Design Review Committee Meeting

August 18, 2021 6:00 PM

Agenda

1 1/4" = 1'-0" BUILDING 1 - NORTH ELEVATION

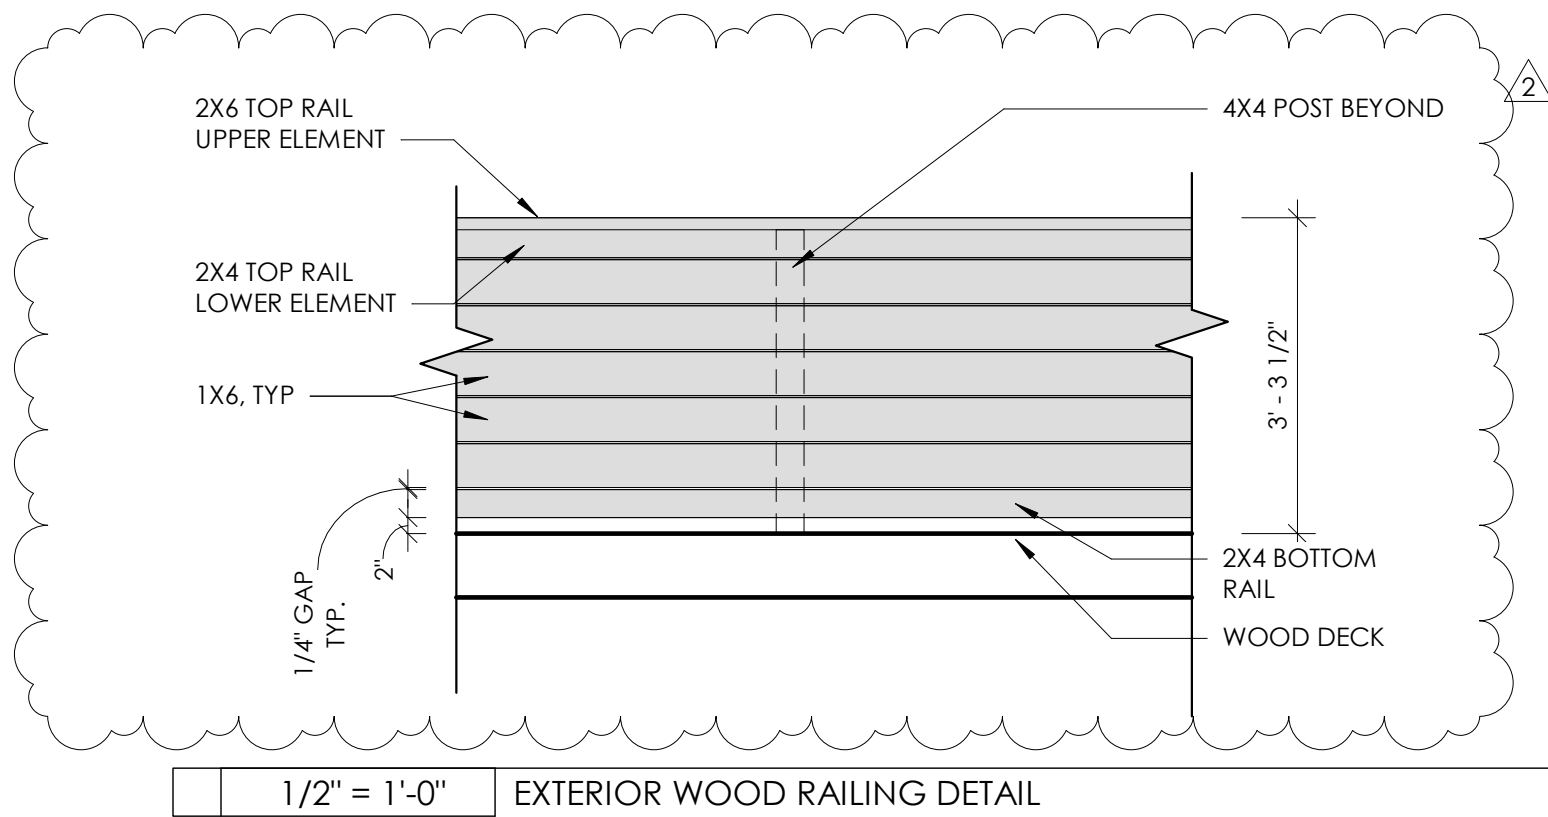
PROPOSED RAILING CHANGES

FRONT ELEVATION

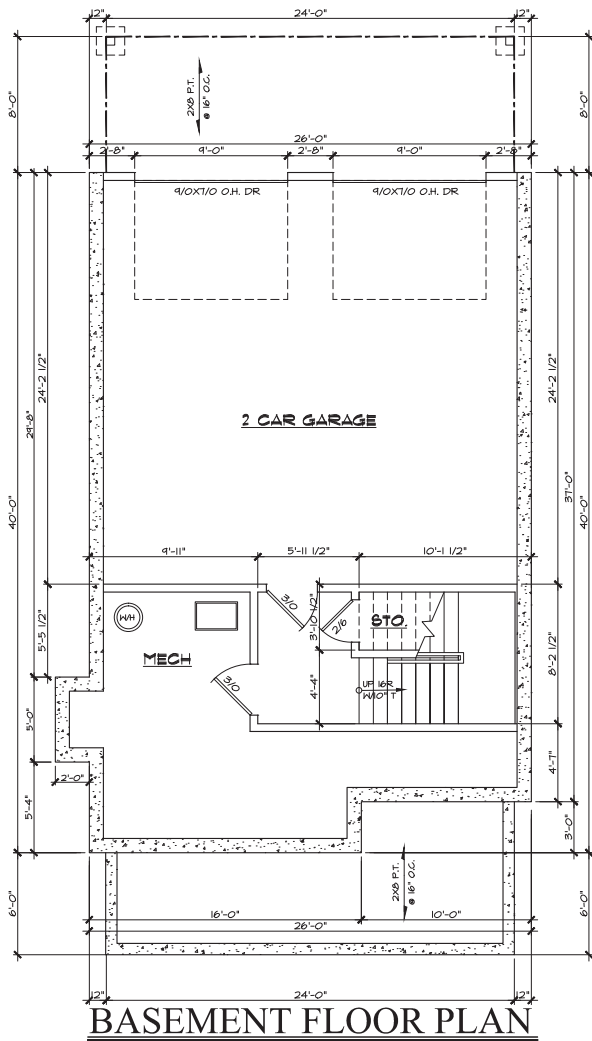
STAFF COMMENT: *Stoops and porch[es] shall be a minimum of two feet and a maximum of four feet from grade to the top of the stairs, unless existing topography is greater. Design Exception Required.*

STAFF COMMENT: *Center mullions should be two inches wider than side trim or Design Exception Required.*

STAFF COMMENT: *Provide sill height.*

ARCHITECTURAL ELEVATION DRAWING

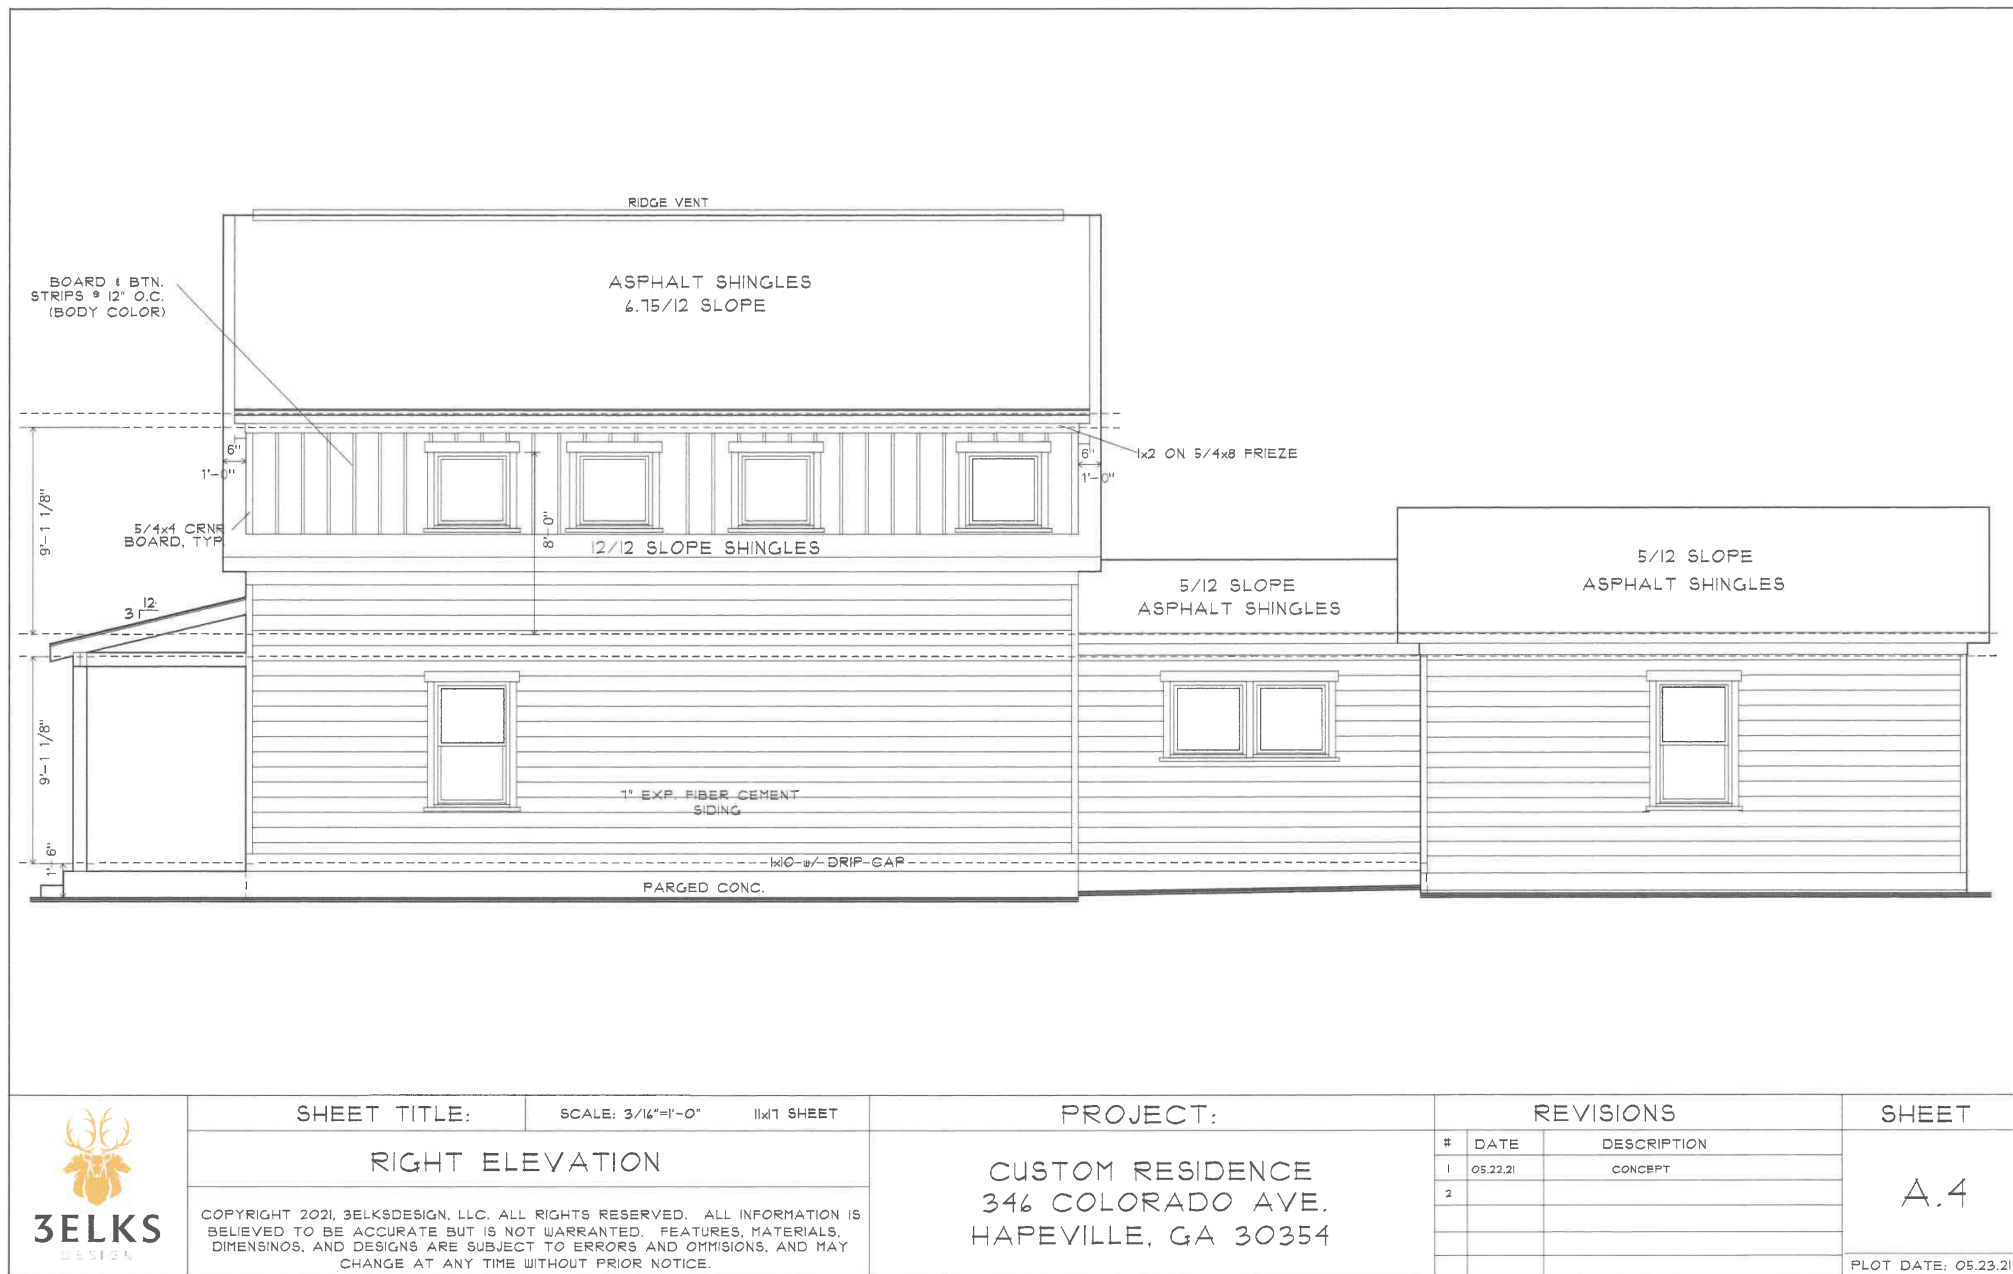
STAFF COMMENT: Chimney is stucco; if allowed will require a Design Exception. Chimney is more than 6' above roof line.

STAFF COMMENT: Porch is 9' for 10' of façade (front door) but 6' from 16' of façade (living room). If allowed, Design Exception required.

STAFF COMMENT: *Provide sill height.*
